BROWNS FERRY NUCLEAR PLANT (BFN) - RESPONSE TO REQUEST FOR
ADDITIONAL INFORMATION REGARDING DESIGN CRITERIA FOR LOWER
DRYWELL STEEL PLATFORMS AND MISCELLANEOUS STEEL (TAC NOS.
M80618, M80619, AND M80620)

ENCLOSURE 1
BROWNS FERRY NUCLEAR PLANT (BFN)
LOWER DRYWELL PLATFORMS AND MISCELLANEOUS STEEL CRITERIA

Figure 1

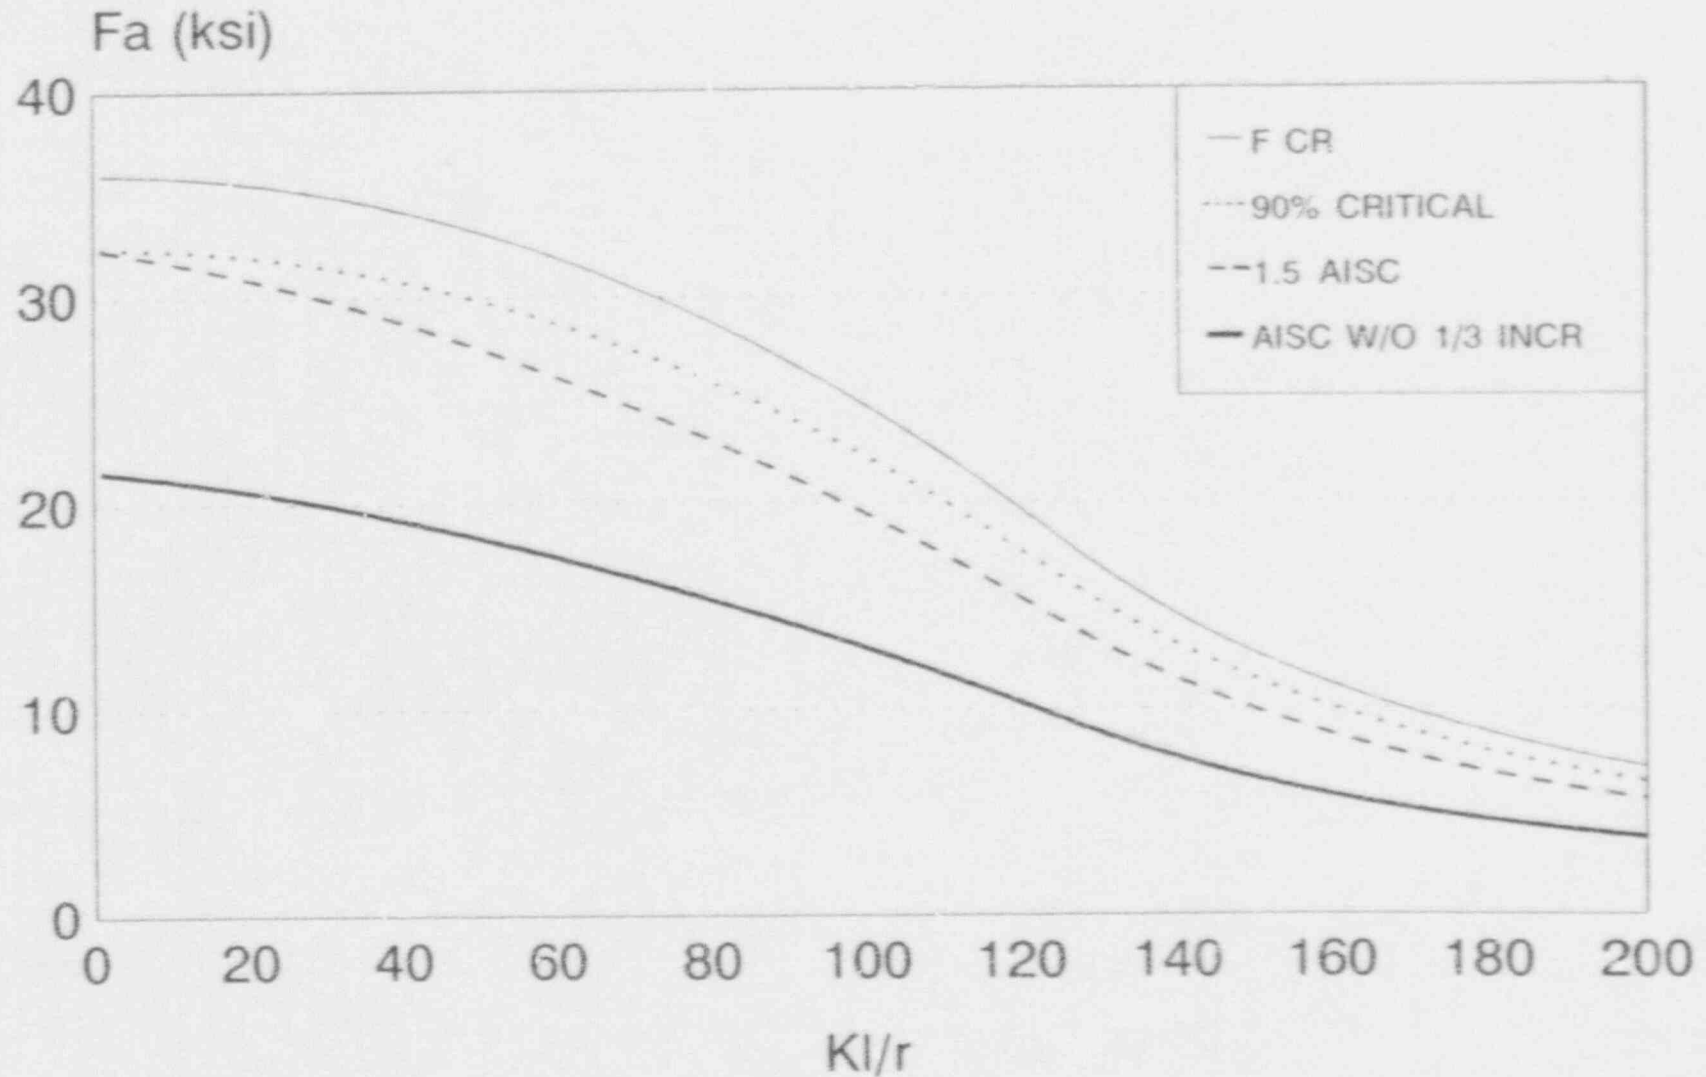
4. SE Section 2.5.2 states the staff does not accept 0.9 of the critical buckling stress, since this limit provides insufficient margin. TVA is requested to submit a lower limit for staff review which demonstrates acceptable margin.

TVA's design criteria specifies a 1.5 increase in the basic AISC stress allowables for the DBE load combination. However, in no case shall allowables exceed 90 percent of critical buckling for axial compression. The $0.9 F_{CR}$ (Factor of Safety = 1.11) is only approached for very short compression members for which buckling is not a concern. This allowable is in accordance with, or more conservative than, standard industry practice.

The allowables for columns are demonstrated by the following examples. Note that $0.9 F_{CR}$ is approached only for columns of very short length. As column length increases, the allowable stress is rapidly reduced to $0.78 F_{CR}$. The example column has an allowable stress of $0.88 F_{CR}$ at a 7.25 inch length. The allowable stress is reduced to $0.81 F_{CR}$ at a 48 inch length and declines to $0.78 F_{CR}$ at a length of 101.33 inches. The factor of safety against critical buckling ranges from 1.11 for the short column, up to 1.28 for the longer column. These factors of safety are consistent with those used for tension and bending members for the DBE loading combination. It has also been observed in physical tests that columns exhibit post-buckling strength and do not fail abruptly in compression. The relationship between a 1.5 increase in basic AISC stresses and $0.9 F_{CR}$ is shown graphically in Figure 1.
